**DIRECT TESTIMONY
OF
BRIAN CONROY, P.E.**

**ON BEHALF OF
LOUDOUN COUNTY, VIRGINIA
BEFORE THE
STATE CORPORATION COMMISSION OF VIRGINIA
CASE NOS. PUR-2024-00032 AND PUR-2024-00044
(COLLECTIVELY, THE CONSOLIDATED CASES)**

500KV & 230KV XLPE DUAL CIRCUIT UNDERGROUND TRANSMISSION LINES SUMMARY ESTIMATE

Exhibit BC-2 (Photo Renditions)

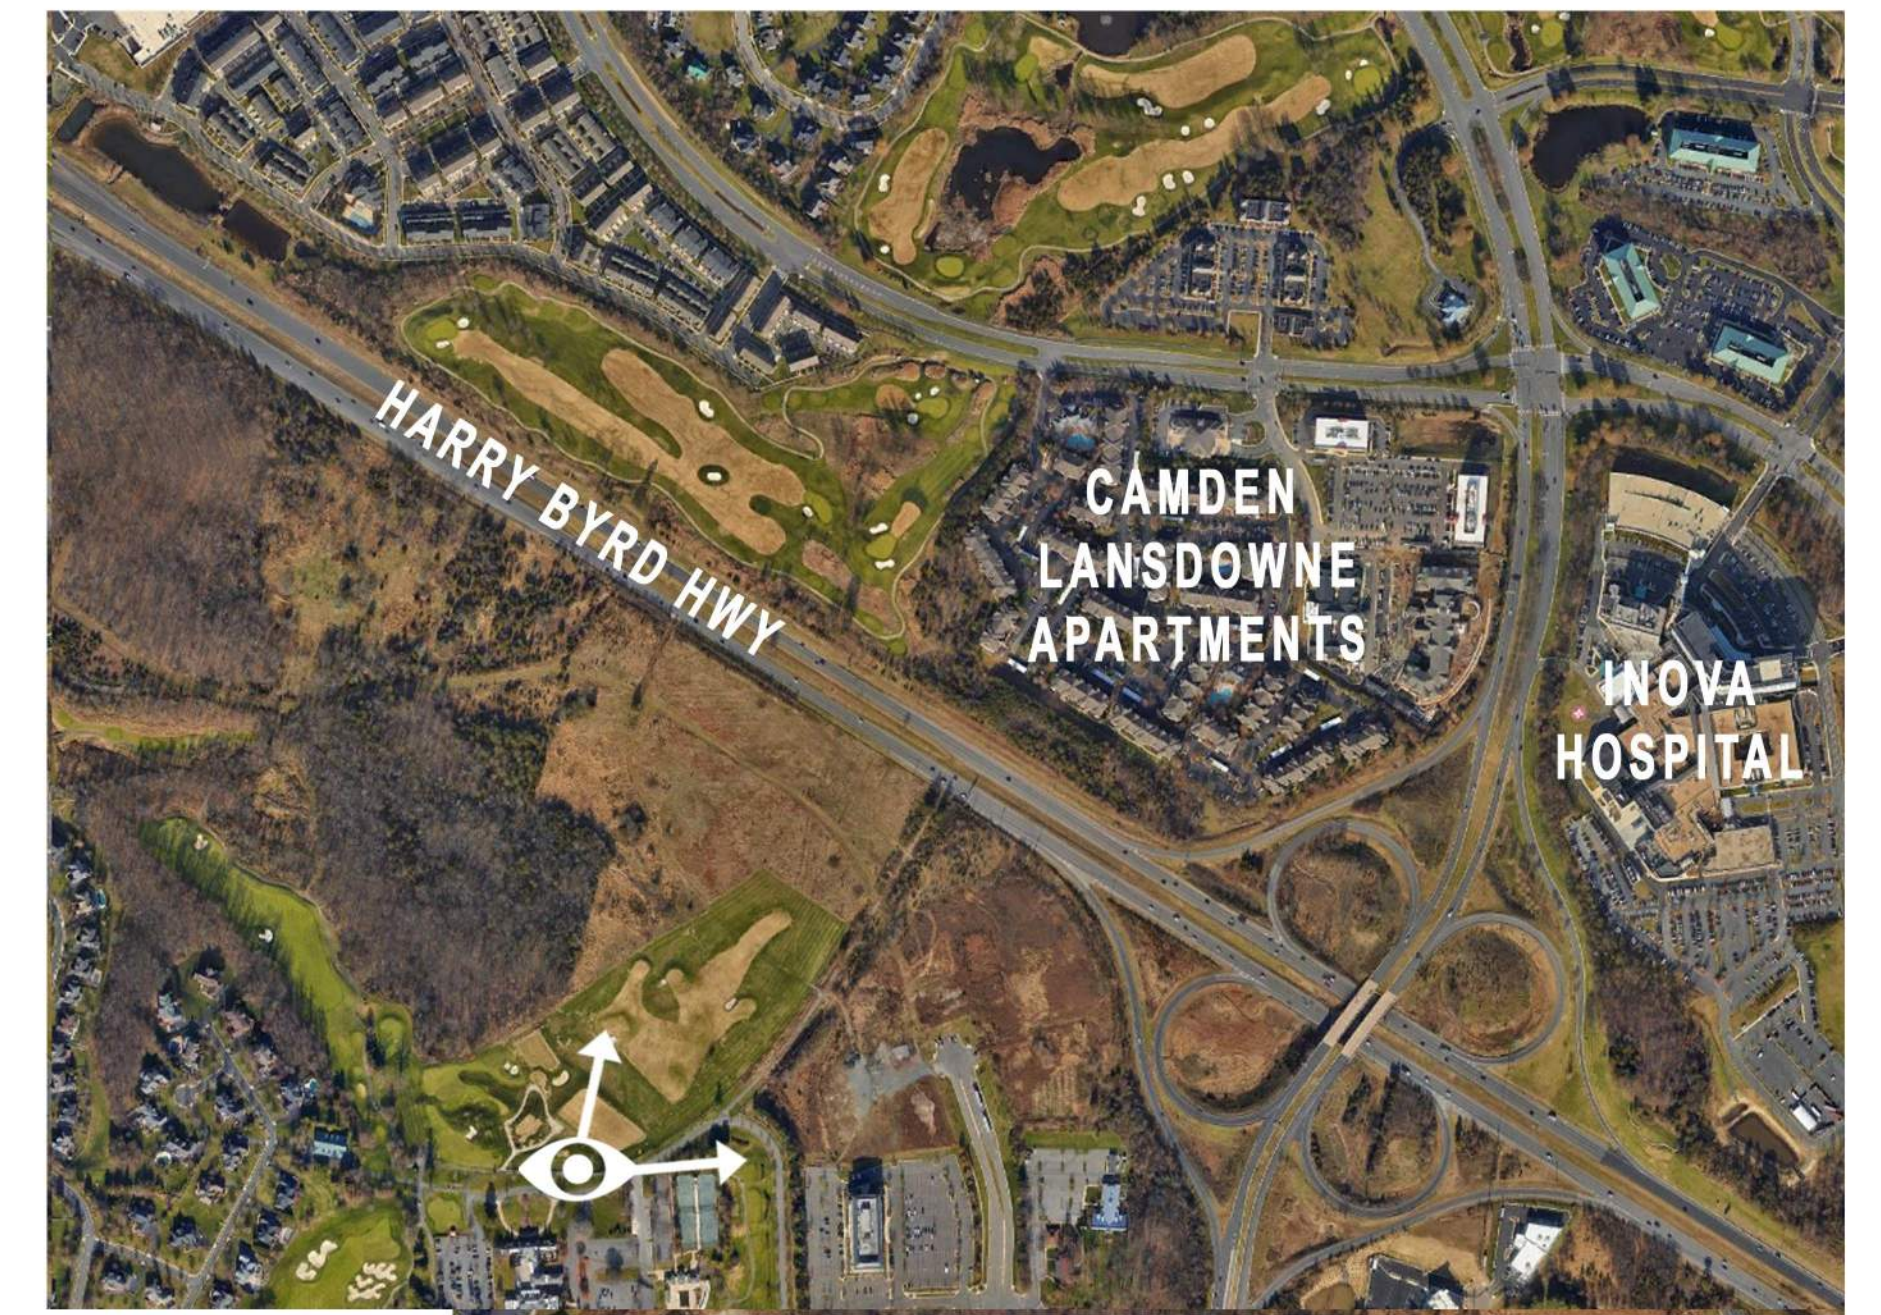
173 Please see the photo renditions in **Exhibit BC-2** to compare the impact of the OH and
174 hybrid options.

- 253 • Visual Impact: The allegation that the visual impact of the transition stations would
254 be exacerbated with this alternative is unfounded. Please see the photo renditions
255 in **Exhibit BC-2** to compare the visual impact of the OH and hybrid options. The
256 transition stations are located on properties zoned for data center use and will blend
257 in with substations located on the property.

Figure 1 - Proposed Transmission Line Routing

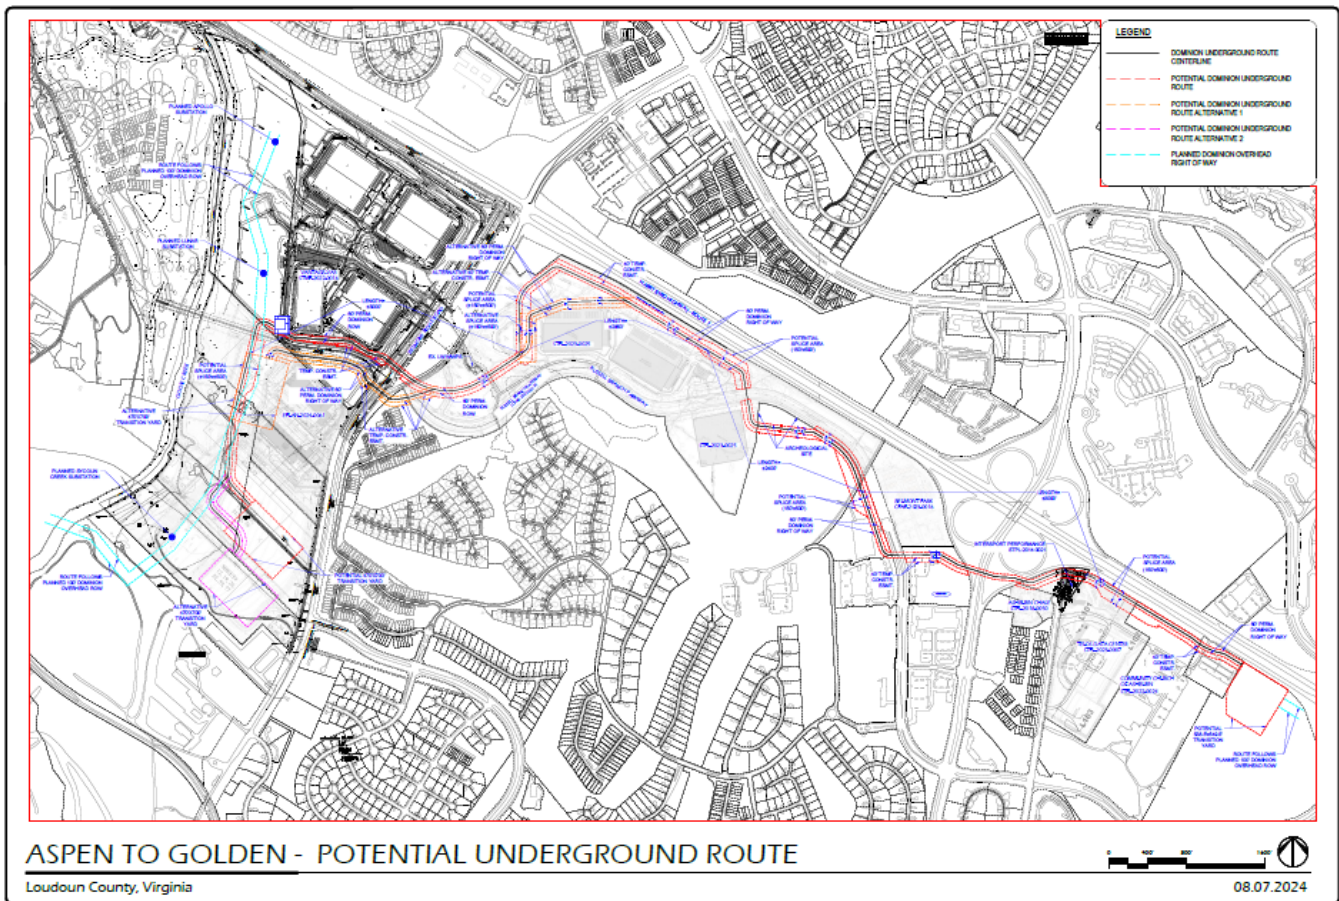
177 A. By designing the section of this route underground from Belmont Ridge Road
178 through the Claiborne Parkway, the negative impact to the uses, easements, and historic
179 sites can be greatly mitigated. *See* Figure 1 - Proposed Transmission Line Routing, in
180 **Exhibit BC-3** – Transmission Line Summary Estimate.

204 Transition stations: RLC has adjusted the area needed to accommodate transition stations
205 and has located viable sites for these stations. The proposed transition stations are
206 estimated to be 470’x700’, and 540’x550’. Please see Figure 1 - Proposed Transmission
207 Line Routing, in **Exhibit BC-3**.

215 Future delivery point requests: Below are the planned data center developments in the
216 proposed UG area, along with options to provide service (reference Figure 1 - Proposed
217 Transmission Line Routing, in **Exhibit BC-3**. Other residential and commercial
218 delivery requests in the area could be served by the local distribution system.

291 Planned Developments: Please see Figure 1 - Proposed Transmission Line Routing, in
292 **Exhibit BC-3**. This routing anticipates known future developments, including:

304 A. The hybrid underground proposal would follow Dominion’s proposed route from
305 the Aspen Substation to nearby the proposed Sycolin Substation. A transition station is
306 proposed at this location, with a 3-mile underground segment, generally following the
307 proposed OH line route, running to the East of the Community Church in Ashburn. At that
308 point, a second transition station is proposed, with the remaining route to Golden
309 Substation following Dominion’s proposal. The basic difference between the Dominion
310 proposal and this hybrid proposal is this 3-mile proposed underground segment. See Figure
311 1 - Proposed Transmission Line Routing, in **Exhibit BC-3**.

Figure 2 - Example Concrete Duct Bank Arrangement

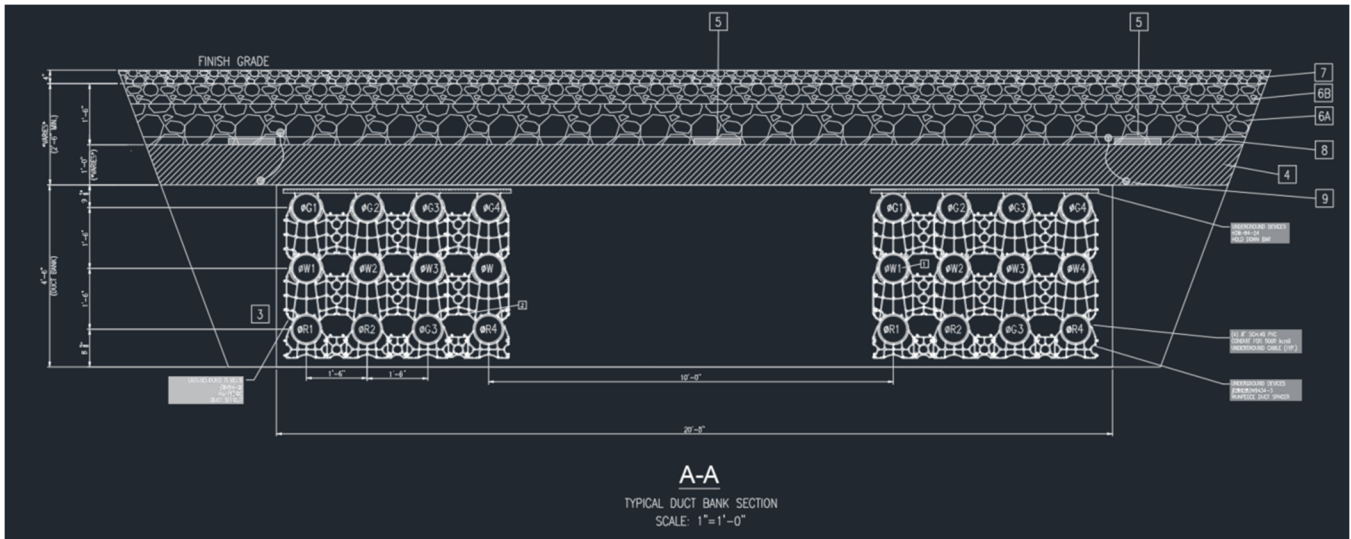
- 246 • Cable and ductbank spacing: RLC revised the ductbank cable spacing and separated
247 the 230 kV and 500 kV into two separate ductbanks. See Figure 2 – Example of
248 Concrete Duct Bank Arrangement, in **Exhibit BC-3** for a typical duct bank section.
